UNITED STATES PATENT AND TRADEMARK OFFICE

APPLICATION NO.	FILING DATE	FIRST NAMED INVENTOR	ATTORNEY DOCKET NO.	CONFIRMATION NO.
10/676,521	10/01/2003	Vincent LaBonia JR.	PLC 10400	8312

Office Action Summary	Application No. 10/676,521	Applicant(s) LABONIA ET AL.	
	Examiner Philip Gabler	Art Unit 3637

DETAILED ACTION

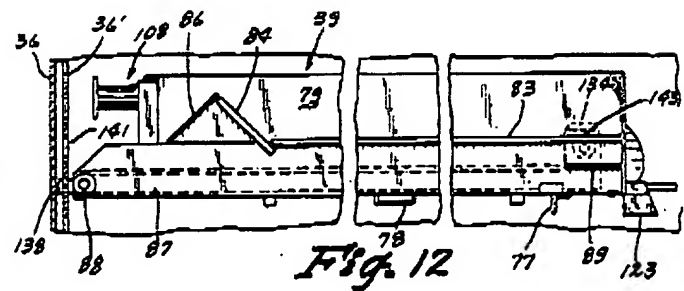
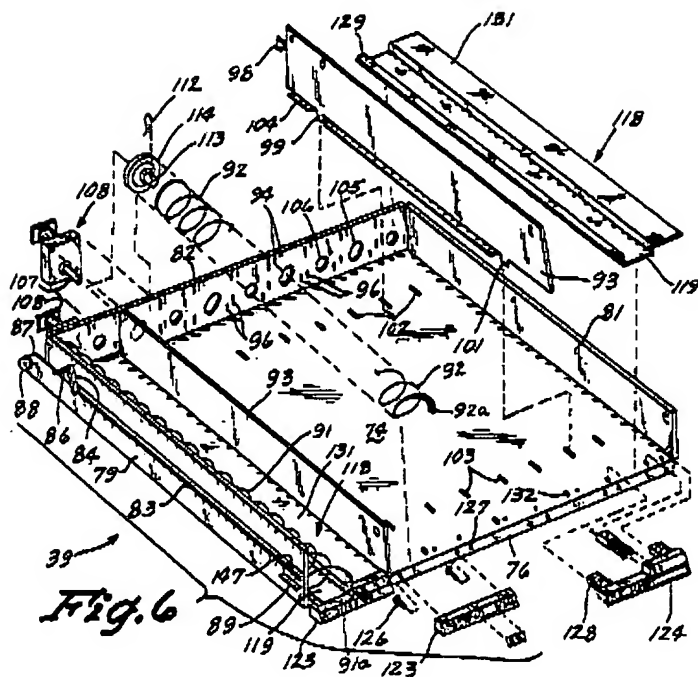
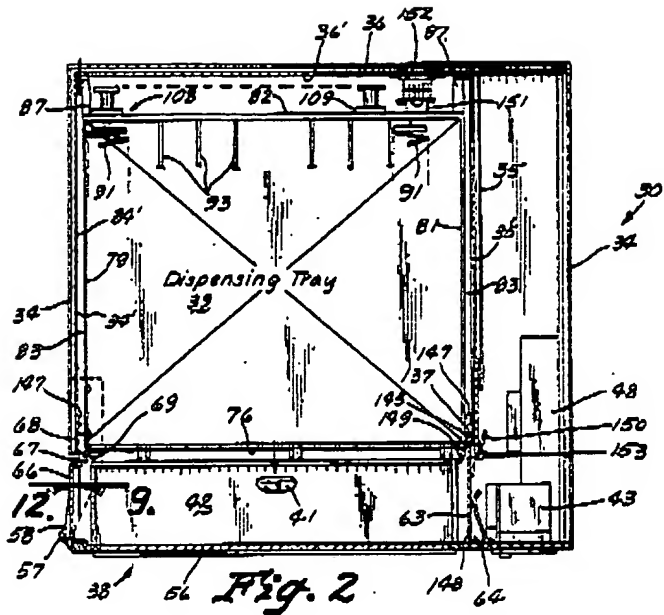
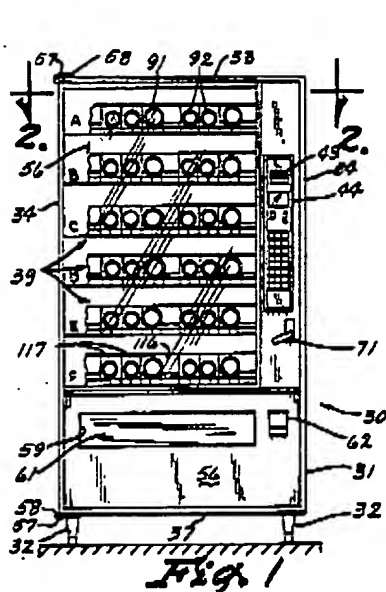
8. Claims 57 and 58 are rejected under 35 U.S.C. 102(b) as being anticipated by Albright et al. (US Patent Number 4757915). Albright (Figures 1, 2, 6, and 12) discloses a storage device comprising: a pair of opposing side panels (34') and (35'), each side panel having a front lengthwise end, a rear lengthwise end, an upper widthwise end, and a lower widthwise end; a top panel (33) attached to the upper widthwise ends of the opposing side panels; a bottom panel (37) attached to the lower widthwise ends of the opposing side panels; a back panel (36') attached to the rear lengthwise ends of the opposing side panels so as to define a housing having an interior; and at least one shelf member (39) positioned within the interior of the housing and attached to the opposing side panels, the at least one shelf member comprising a shelf panel (39) that has a

Exhibit 1: Bienick '673 Figures 3 and 5

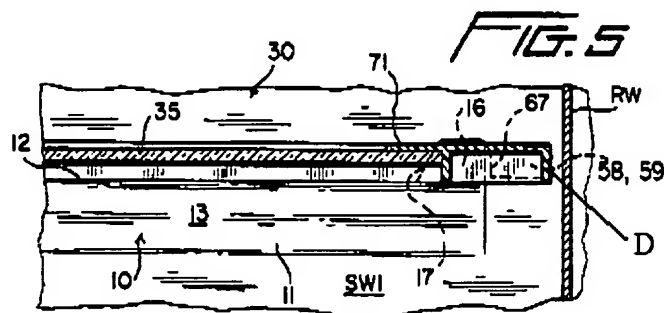
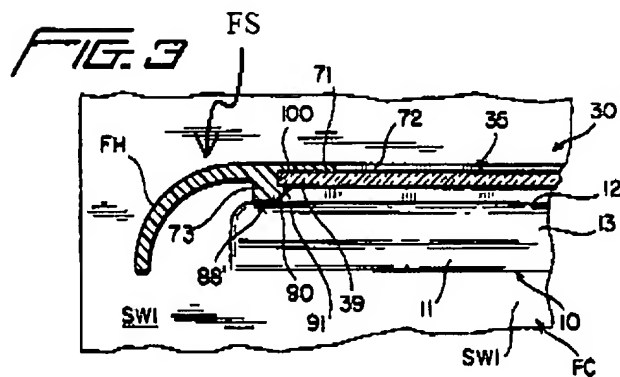
9. Claims 57 and 58 are rejected under 35 U.S.C. 102(e) as being anticipated by Bienick (US Patent Number 6422673). Bienick discloses a storage device comprising: a pair of opposing side panels (viewed as A in Exhibit 2), each side panel having a front lengthwise end, a rear lengthwise end, an upper widthwise end, and a lower widthwise end; a top panel (B) attached to the upper widthwise ends of the opposing side panels; an inherent bottom panel (not shown) attached to the lower widthwise ends of the opposing side panels (as is conventionally known in the art, i.e. the compartment of Bienick would be bounded by at least a top, a bottom, a back, and two side panels); a back panel (C) attached to the rear lengthwise ends of the opposing side panels so as to define a housing having an interior; and at least one shelf member (30) positioned within the interior of the housing and attached to the opposing side panels, the at least one shelf member comprising a shelf panel (30) that has a predetermined length, a generally planar top side (35) capable of storing parts thereon, a bottom side (opposite 35), a front lengthwise end section (viewed as FS in Exhibit 1) that is proximate to the front of the storage bin and which extends for the entire predetermined length of the shelf panel, and a rear lengthwise end section (D) that is adjacent to the back panel, the front lengthwise end section comprising an inclined section (FH) that has a length that is substantially equal to the predetermined length of the shelf panel, the inclined section being angulated with respect to the generally planar top side of the shelf panel such that the angle measured between the inclined section and the generally planar top side is greater than 90° (it is in fact greater than 180° when measured from the horizontal axis), the front lengthwise end section further comprising a front wall section (73) that is

attached to and extends for substantially the entire length of the inclined section, the front wall section being angulated with respect to the inclined section in accordance with a second predetermined degree of angulation such that the front wall section is positioned across from the inclined section (note Figure 3) and substantially parallel to the back panel. As to the last paragraph, it has been held that the function "whereby" statement does not define any structure and accordingly cannot serve to distinguish. As an aside, Bienick's shelf would allow a user to easily slide parts off of the top side of the shelf panel as readily apparent to the examiner. Regarding claim 58, Bienick further discloses a plurality of shelf members wherein all of the front wall sections are substantially coplanar.

Exhibit 1: Bienick '673 Figure 1

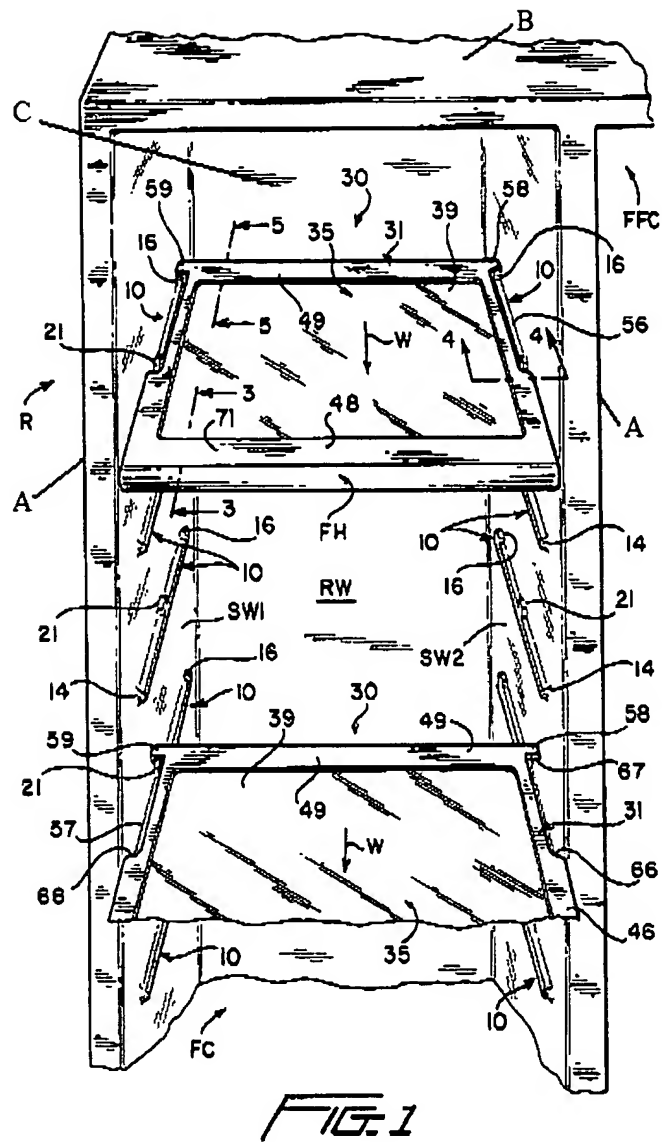
11. Claims 57 and 58 are rejected under 35 U.S.C. 103(a) as being unpatentable over Bienick in view of Lye et al. (US Patent Number 6227636). Bienick discloses a storage device comprising: a pair of opposing side panels (viewed as A in Exhibit 1), each side panel having a front lengthwise end, a rear lengthwise end, an upper widthwise end, and a lower widthwise end; a top panel (B) attached to the upper widthwise ends of the opposing side panels; a back panel (C) attached to the rear lengthwise ends of the opposing side panels; and at least one shelf member (30) positioned within the interior of the housing and attached to the opposing side panels, the at least one shelf member comprising a shelf panel (30) that has a predetermined length, a generally planar top side (35) capable of storing parts thereon, a bottom side (opposite 35), a front lengthwise end section (viewed as FS in Exhibit 1) that is proximate to the front of the storage bin and which extends for the entire predetermined length of the shelf panel, and a rear lengthwise end section (viewed as D in Exhibit 1) that is adjacent to the back panel, the front lengthwise end section comprising an inclined section (FH) that has a length that is substantially equal to the predetermined length of the shelf panel, the inclined section being angulated with respect to the generally planar top side of the shelf panel such that the angle measured between the

Lye et al. '636 Figure 1

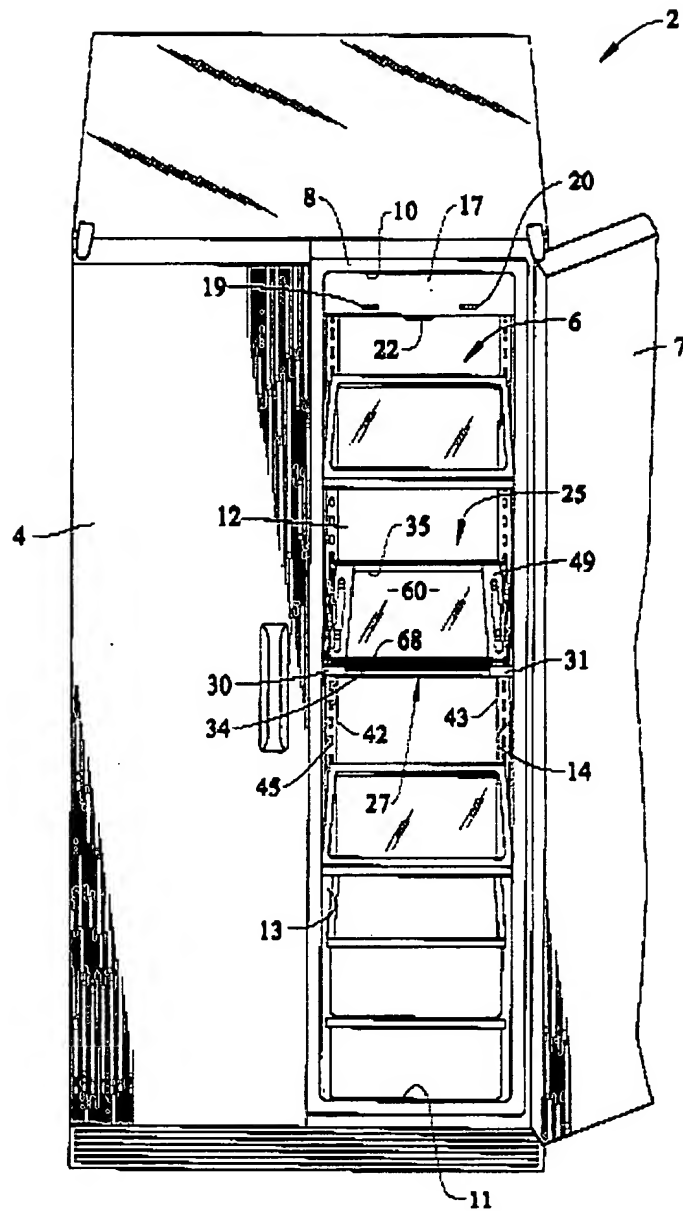
inclined section and the generally planar top side is greater than 90° (it is in fact greater than 180° when measured from the horizontal axis), the front lengthwise end section further comprising a front wall section (73) that is attached to and extends for substantially the entire length of the inclined section, the front wall section being angulated with respect to the inclined section in accordance with a second predetermined degree of angulation such that the front wall section is positioned across from the inclined section (note Figure 3) and substantially parallel to the back panel. As to the last paragraph, it has been held that the function "whereby" statement does not define any structure and accordingly cannot serve to distinguish. As an aside, Bienick's shelf would allow a user to easily slide parts off of the top side of the shelf panel as readily apparent to the examiner. While the bottom panel was viewed as being an inherent feature in the previous 102(e) rejection, the examiner further demonstrates this assertion by incorporating the evidence of the Lye reference. Lye (Figure 1) discloses a storage device comprising a housing including a bottom panel (11) attached to the lower ends of opposing side panels (13) and (14). As such, it would have been obvious to one of ordinary skill in the art to modify the storage device of Bienick to include a bottom panel because this arrangement would complete the housing of Bienick's device, making the enclosure complete and functional as a refrigerator as described. Regarding claim 58, Bienick further discloses a plurality of shelf members wherein all of the front wall sections are substantially coplanar.
